ADDENDUM #1

SOLICITATION NUMBER AND TITLE:	IFB 23B-006: CHESAPEAKE WELCOME CENTER RENOVATION AND EXPANSION PROJECT	
SOLICITATION DUE DATE AND TIME:	May 31, 2023	1:00 PM Local Time
DELIVERY LOCATION OF SUBMITTAL:	HARFORD COMMUNITY COLLEGE Procurement Dept. 401 Thomas Run Road, Bel Air, MD 21015 Conowingo Building, Suite 105	
BID OPENING	May 31, 2023	2:00 PM Local Time Chesapeake Center – Dining Room North
PRE-SOLICITATION MEETING LOCATION:	Chesapeake Center- Dining Room North	
QUESTIONS DUE DATE AND TIME:	<u>CHANGED:</u> May 9, 2023	5:00 PM Local Time
PROCUREMENT DIRECTOR:	Questions must be received by the date and time noted above via email to: Christine Carpenter at <u>ccarpenter@harford.edu</u>	
BID DEPOSIT:	Bid Deposit – 10% of bid price	
MBE GOAL:	10% of bid price	
BONDING REQUIREMENTS:	100% Payment & Performance Bond	
INSURANCE REQUIREMENTS:	Construction with Builders Risk	
PREVAILING WAGE:	Prevailing Wage Required

Chesapeake Welcome Center Renovation & Addition Project

Addendum #1

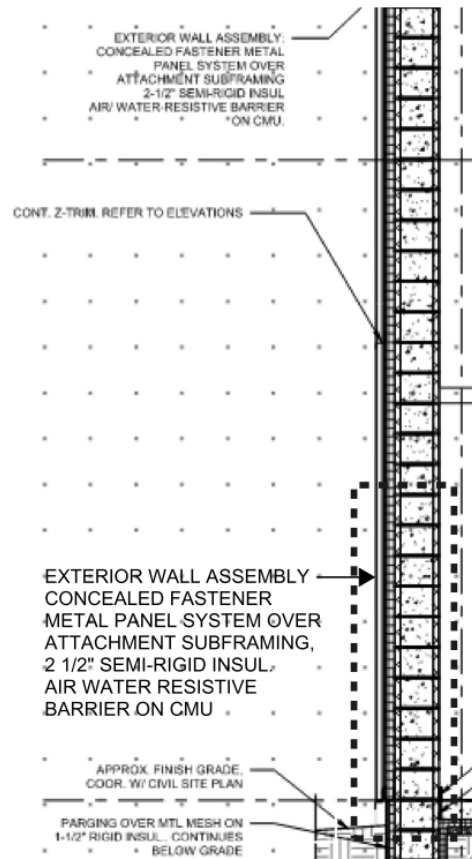
- Item 1.7. Include additional details for the mock up panel with attachments SK-01 and SK-02. Please note that these sketches are in addition to the requirements found in Specification Section 01 43 39.

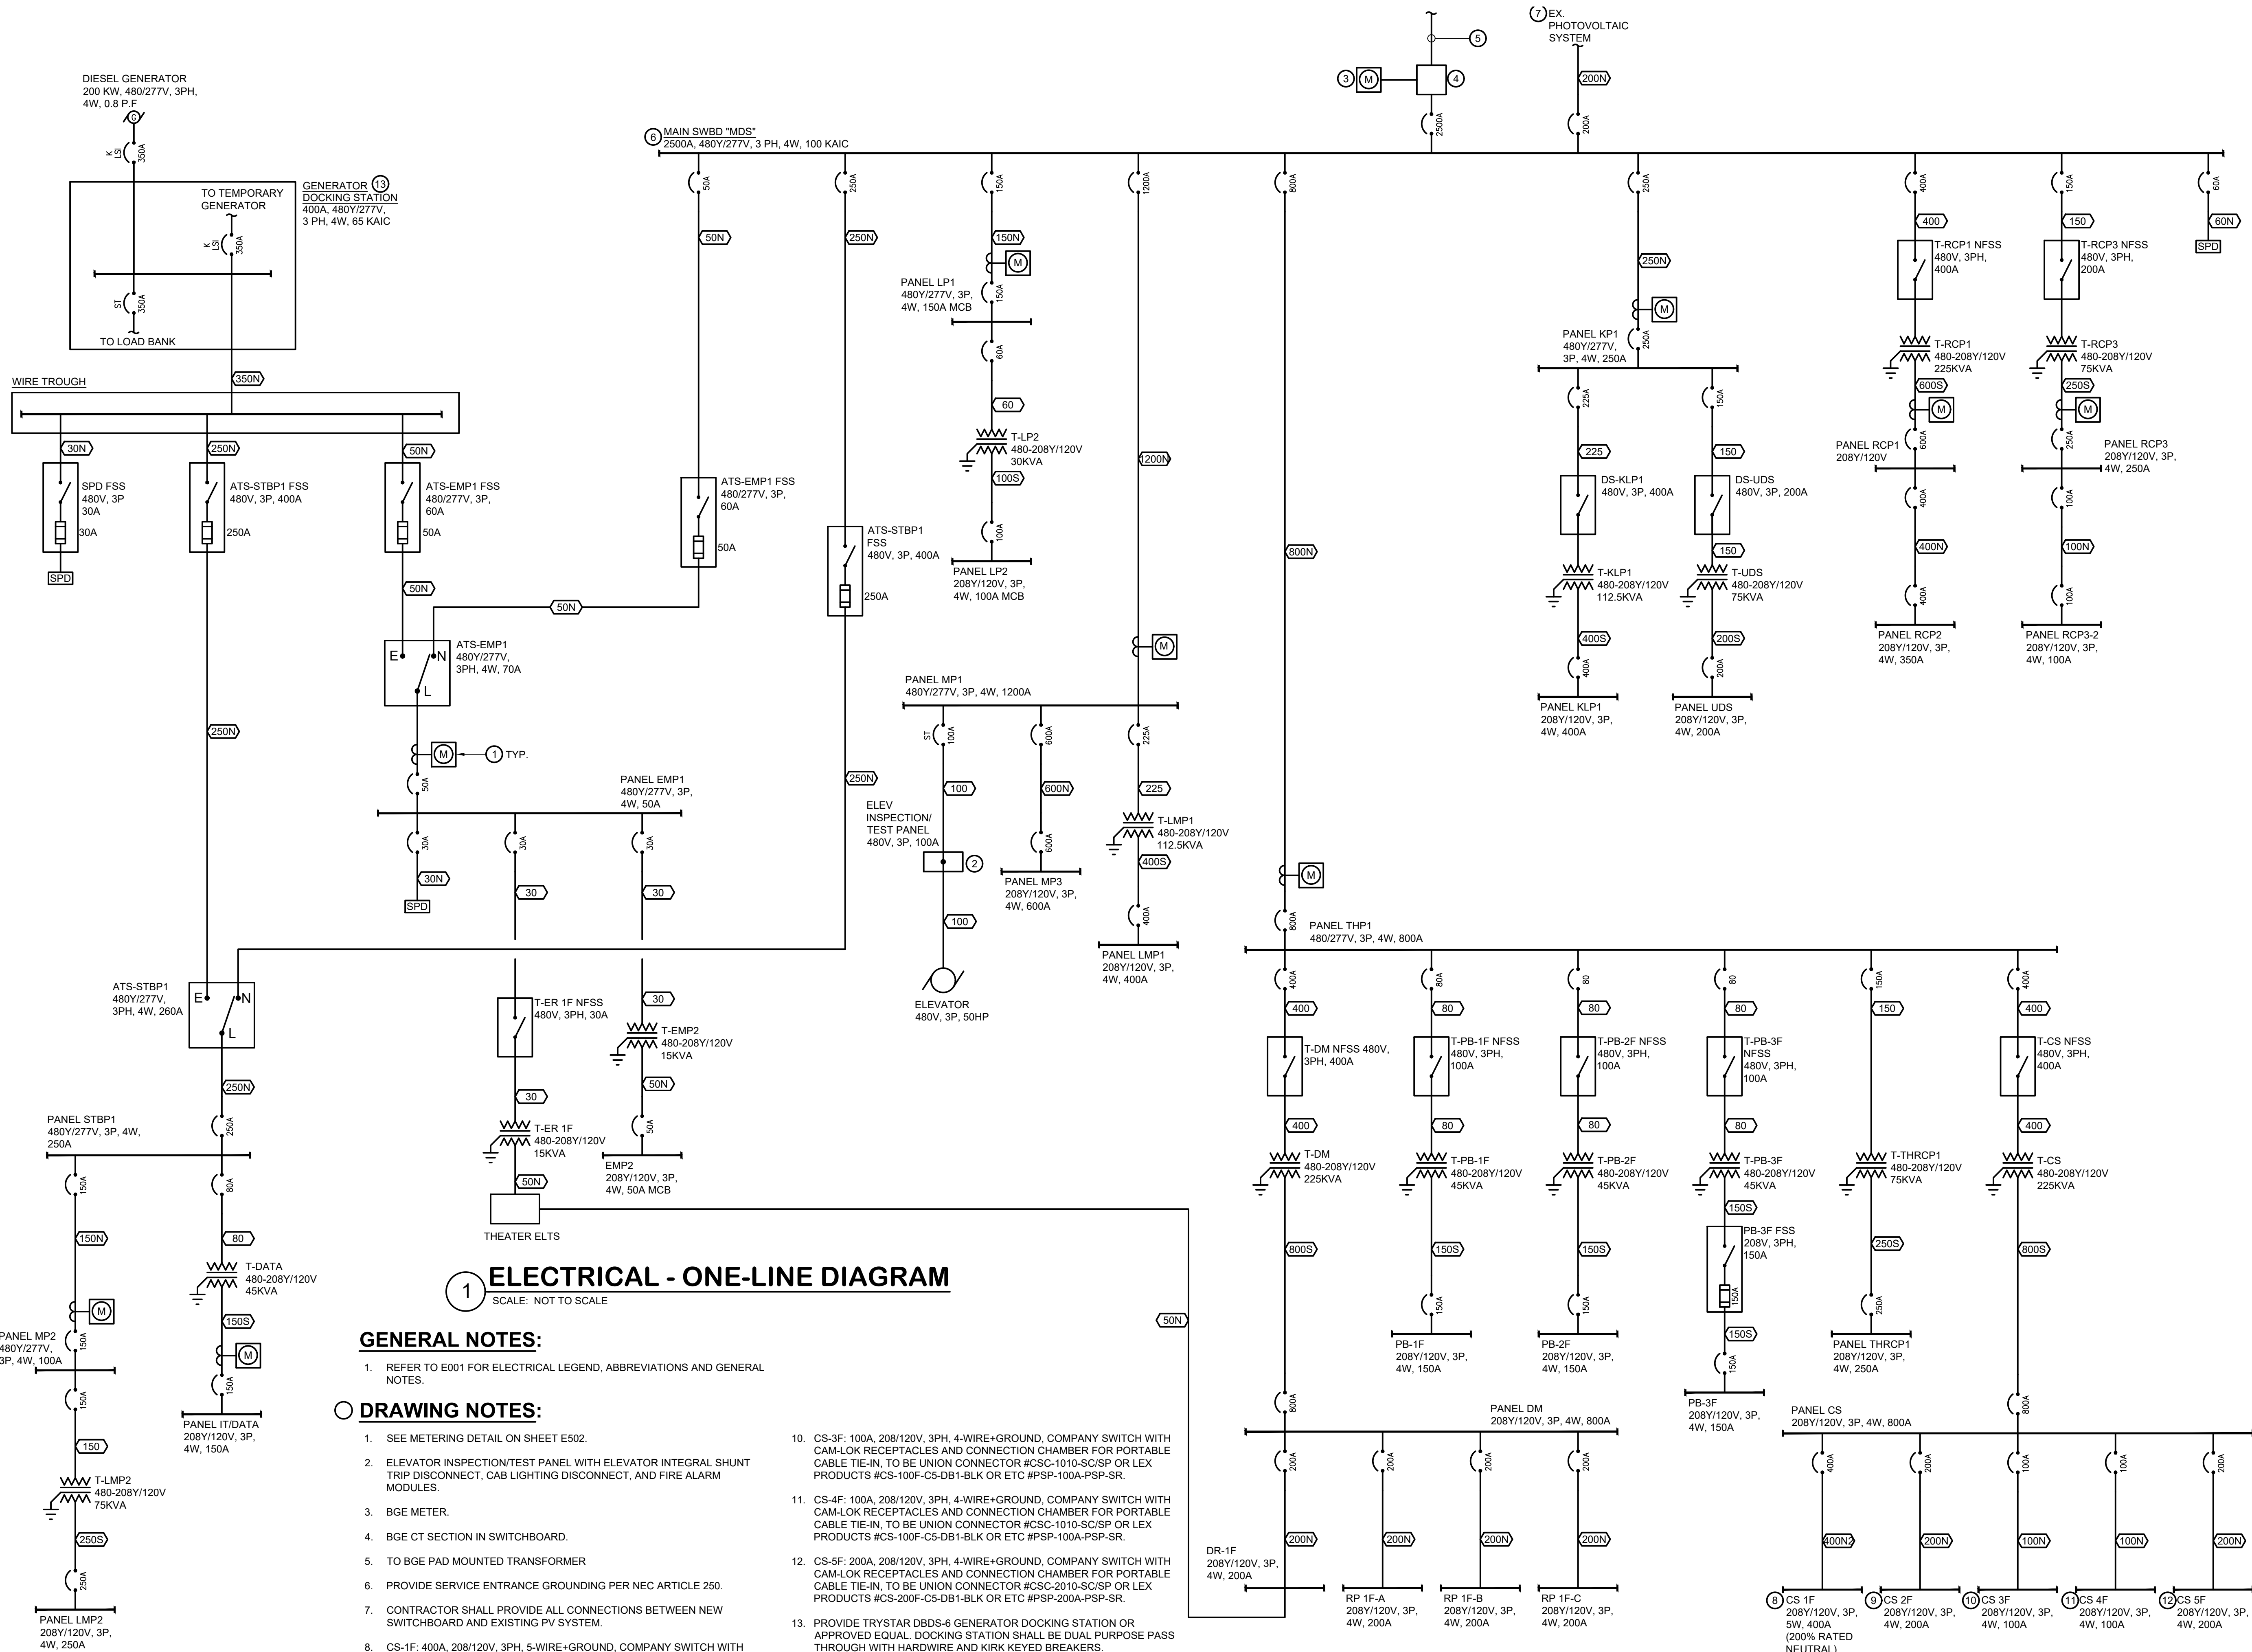
- Item 1.20. Please see attachment showing a potential location on campus to relocate the Kitchen services.
- Item 1.21. The Owner is a member of E&I Cooperative Services (www.eandi.org) and the awarded Contractor and Trade Subcontractors can use E&I Cooperative Services contracts to fulfill product requirements where E&I Cooperative Services holds an agreement. For the list of products please visit their website and/or contact Bob Solak at Bsolak@eandi.org.
